PCN – Process Change Notification

Change:	FW.80.SMA.M
Date:	2017/08/04
Author	Haley Tsai

Model#	Part Number	Changes
169MHz Flexible Whip Antenna SMA(M) Straight	FW.80.SMA.M	<ol style="list-style-type: none"> 1. Amend $\varnothing 4 \pm 0.3\text{mm}$ to $3.7 \pm 0.2\text{mm}$. 2. Amend $\varnothing 61 \pm 0.3\text{mm}$ to $\varnothing 61 \pm 0.5\text{mm}$. 3. Amend $\varnothing 16.05 \pm 0.2\text{mm}$ to $\varnothing 16 \pm 0.5\text{mm}$. 4. Amend cap material from ABS to POM.

Illustration of Change

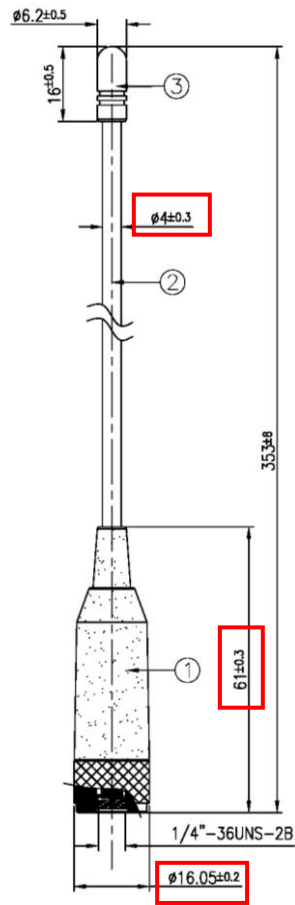
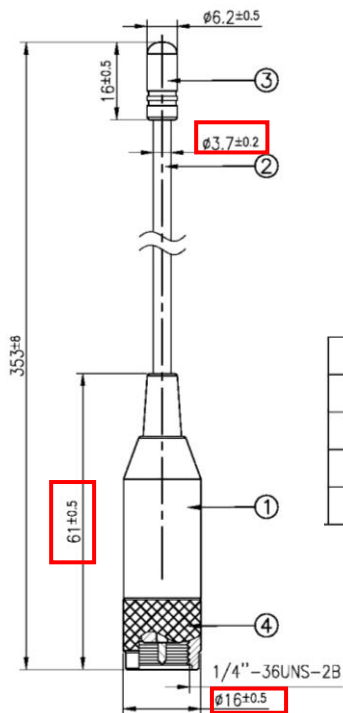
1. Amend $\varnothing 4 \pm 0.3\text{mm}$ to $3.7 \pm 0.2\text{mm}$.
2. Amend $\varnothing 61 \pm 0.3\text{mm}$ to $\varnothing 61 \pm 0.5\text{mm}$.
3. Amend $\varnothing 16.05 \pm 0.2\text{mm}$ to $\varnothing 16 \pm 0.5\text{mm}$.
4. Amend cap material from ABS to POM.
